Planning Commission Staff Report

April 23, 2014
Item 5.b.

SUBJECT: PUD-85-02-02D-06M

PURPOSE: Application for PUD Major Modification to the existing PUD Development Plan (PUD-85-02-02D) for: (1) the phased demolition of all existing buildings; and (2) the construction and operation of an approximately 83,300-square-foot automobile showroom and service facility for Lexus of Pleasanton.

FIGURE 3: Proposed Landscaping Plan

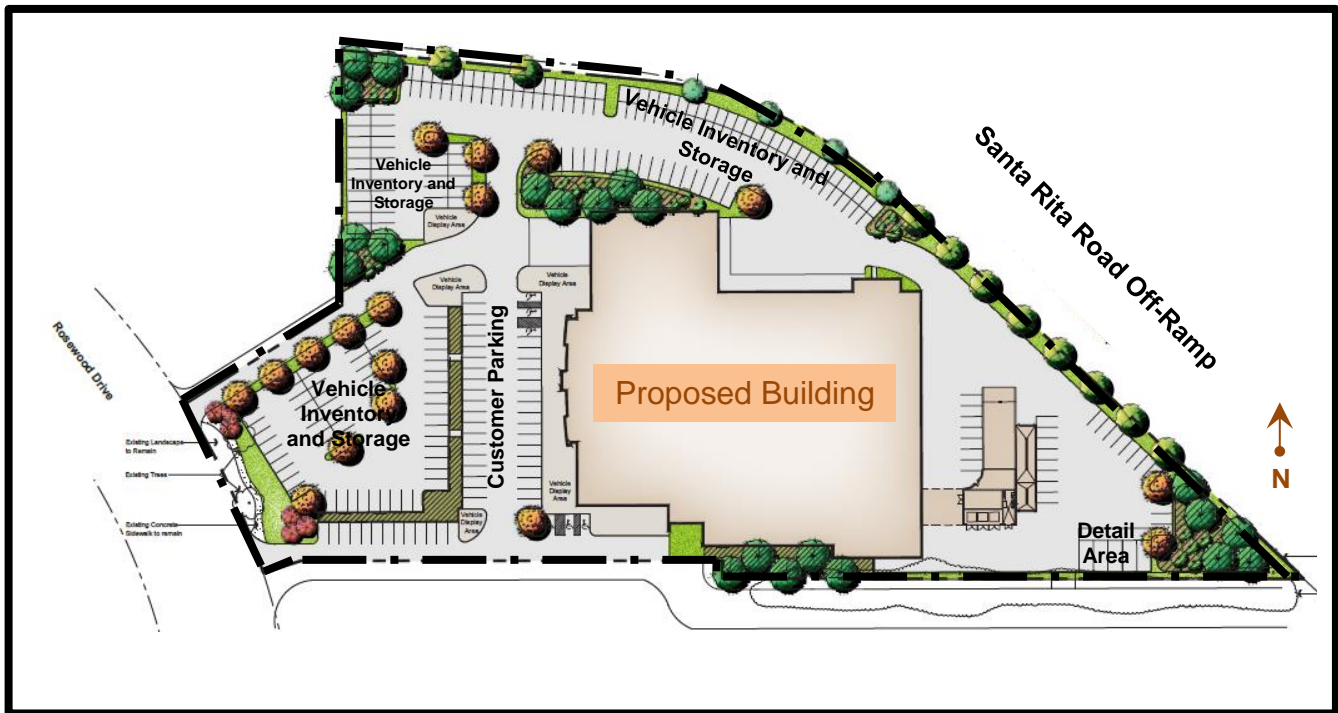
A condition of approval also requires that trees be incorporated in the landscaping area adjacent to and in vicinity to the customer parking area (where there are currently no trees shown). Since no landscaping is proposed adjacent to the showroom and service building, a condition of approval requires landscaping in planter boxes and/or pots be provided in

this area. Finally, another condition requires that a more drought-tolerant species than the River Birch, and a more frost-resistant shrub than the proposed Bottlebrush be incorporated into the final landscaping plans included with plan check plans.

FIGURE 7: Aerial photograph identifying required traffic improvement to northbound left turn lane at Santa Rita Road and Rosewood Drive

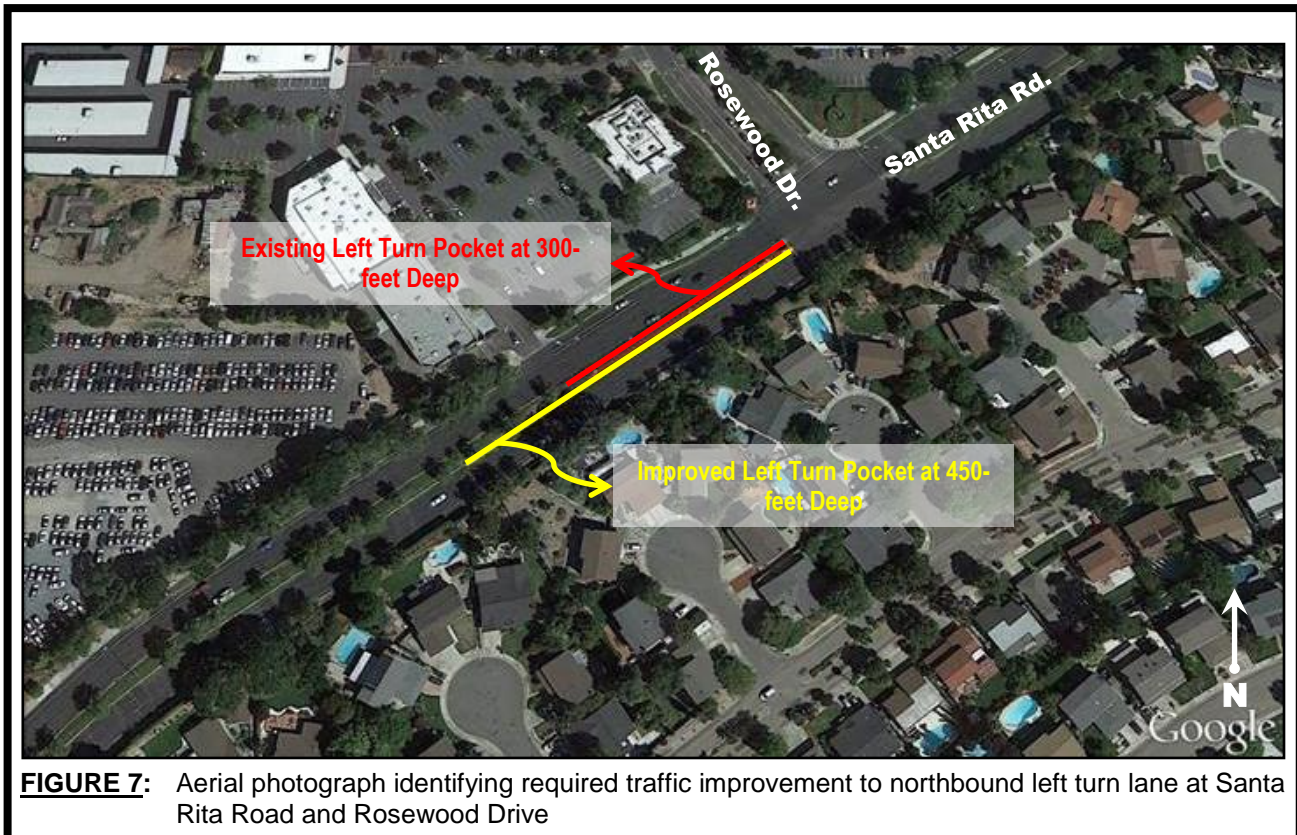
The City Traffic Engineer has not required a traffic report for the subject project, but has identified an improvement that the applicant would have to construct to the north-bound left turn lane at the intersection of Santa Rita Road and Rosewood Drive. This left-turn lane would be required to be extended by approximately 150 feet, from the existing 300-foot depth to approximately 450-foot deep (please reference Figure 7). Construction of the improvement results in the loss of 6 to 7 trees within the existing median. A condition of approval requires this improvement to be constructed prior to Certificate of Occupancy of the final phase of construction.

The improvement identified in Figure 7 is not identified as project in the Pleasanton Traffic Impact Fee (T.I.F.), but the City Traffic Engineer expects that this improvement will be identified in the next T.I.F. update and recommends the cost of this improvement be credited towards the project's T.I.F. fees. The project's construction of the improvement and payment of T.I.F. will mitigate its increase in traffic and help pay for mitigations already identified in the traffic impact fee report and General Plan.
